## **TOGA CENTRAL (FORMER PARCEL POST BUILDING)– MODIFICATION TO SSD-20240923 - RESPONSE TO SUBMISSIONS (BUILT HERITAGE)**

This letter has been prepared in response to the agency comments relevant to Modification 2 of SSD – 20240923. This letter specifically responds to the heritage comments provided by City of Sydney, Heritage NSW and the National Trust. Comments are reproduced in bold below with a response in standard text below each.

Figure 1 Approved ground floor plan

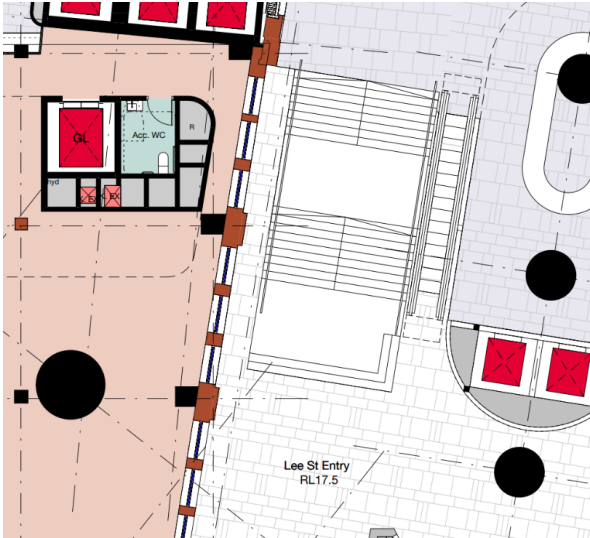
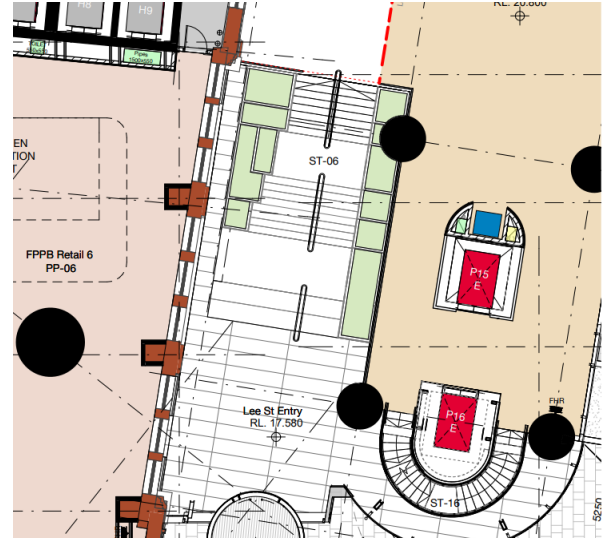
**The City is concerned that the proposed stair and additional planting appears to abut the fPPb. The approved design provided a space, separating old and new, between the stair and the walls of the heritage building. This allowed for the facade to be visible. The proposal obscures the heritage fabric which is not supported. Additionally, it is recommended that the escalator be retained for ease of pedestrian movement.**

The addition does not abut the fPPb. It has a substantial setback from it as shown in the design report. The south façade will be easily visible as viewers move from the west. The planters occupy space that was previously occupied by the approved stairs, they don't encroach further towards the south façade than the stairs.

There is no change proposed to the relationship between the approved stairs and the southern façade as shown in the comparison below.

### South junction of brick retaining wall modified

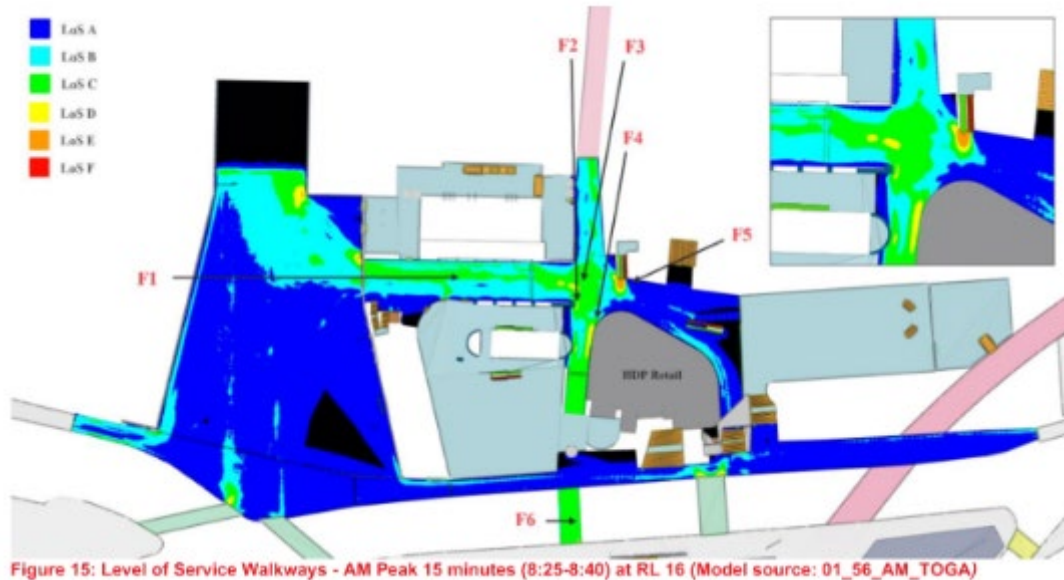
**The City raises concern with the partial removal (and non-reinstatement) of the highly significant brick retaining wall on the site boundary. This would have a negative impact on a significant element of the heritage item**

Some heritage impacts are acknowledged; however, the demolition plans have been updated to indicate the limited extent to which the wall would be demolished and not reinstated. There are opportunities through interpretation to indicate the original extents of the wall.

Note that through investigations associated with the Atlassian site adjacent is has been found that this wall is at least already partly reconstructed. Some sandstone detailing has been replaced with the same foam that exists to the eastern façade of the Parcel Post building. The southern end of the brick wall would be reconstructed on a new alignment. While it would represent a departure from the original design, it would provide an opportunity to reinstate authentic 'noble' materials to the wall.

The below snapshot from the pedestrian modelling report shows the outcome of the pedestrian modelling which highlights the challenges with retaining the southern extend of the wall. The wall is in the vicinity of the area identified as F4 in the modelling. The model indicates that this area is at capacity. The outcome is caused by the use of the Link Zone and increased conflicting, multidirectional movements. The Pedestrian Modelling Report notes that unforeseen circumstances may result in significant delays congestion or performance failure and identified one of the mitigation measures to be planning for where access points and queuing may occur. The southern end of the wall has been identified to impede on pedestrian circulated and is therefore proposed to be removed.

Figure 15: Level of Service Walkways - AM Peak 15 minutes (8:25-8:40) at RL 16 (Model source: 01\_56\_AM\_TOGA)

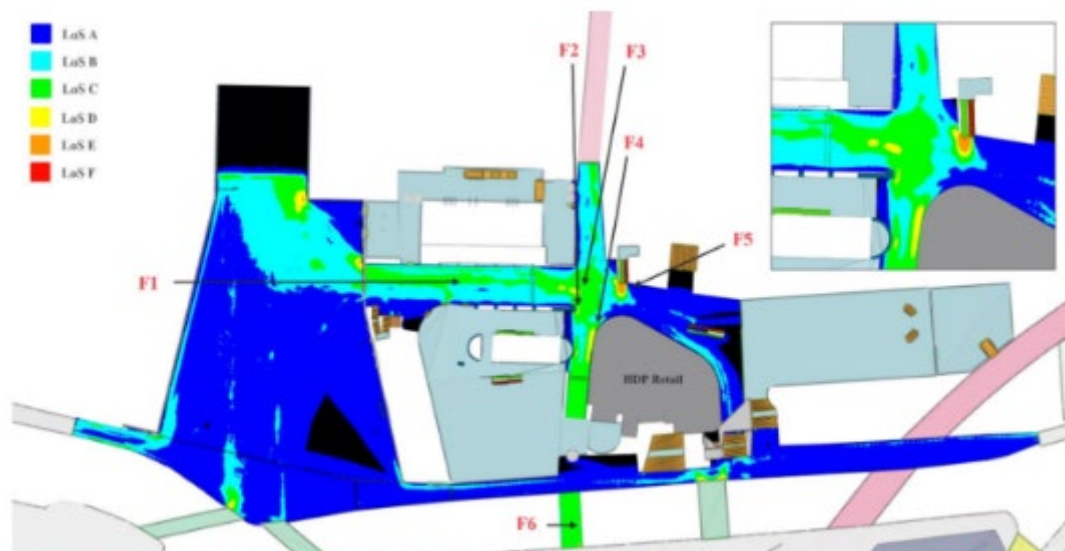
The proposed changes include the removal of the southern section of a brick retaining wall in the eastern section of the site, which is identified as an element of high significance in the CMP. This will be replaced by a new section of wall with a modified shape.

The HIS recommends that in-ground treatment is employed as a part of interpretation to indicate the original location of the wall, and that any bricks from the wall should be salvaged for reuse elsewhere.

Given the significance of this element, Heritage NSW requests additional information regarding the justification for this change to the design and any alternatives considered in design development.

Some heritage impacts are acknowledged. There are opportunities through interpretation to indicate the original extents of the wall.

The below snapshot from the pedestrian modelling report shows the outcome of the pedestrian modelling which highlights the challenges which retaining the southern extend of the wall. The wall is in the vicinity of the area identified as F4 in the modelling. The model indicates that this area is at capacity. The outcome is caused by the use of the Link Zone and increased conflicting, multidirectional movements. The Pedestrian Modelling Report notes that unforeseen circumstances may result in significant delays congestion or performance failure and identified one of the mitigation measures to be planning for where access points and queuing may occur. The southern end of the wall has been identified to impede on pedestrian circulated and is therefore proposed to be removed.
